Product Change Notification					PCN Derating USFF 1206		
owner	creation date	release date	released by	change order no	rev	page	D10-000-679
ganderka	2015-12-18	2016-01-13	bergerra	2008873	A	1 of 2

Fig. 1

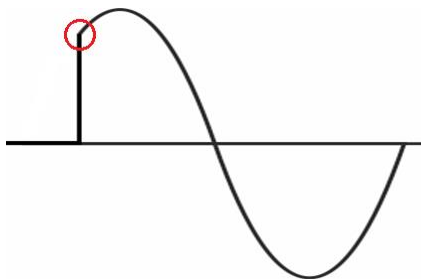
The USFF fuse passed prior UL testing at 100A / 125VAC. The derating is attributed to the fact that UL uses a range of closing angles for testing breaking capacity. The closing angle describes the angle of the sine wave at the moment when the test circuit is switched on. It determines the amount of energy of the signal and hence the results. Refer to Fig. 1 below.

The published breaking capacity for applications > 32VAC has been derated on our datasheet accordingly.
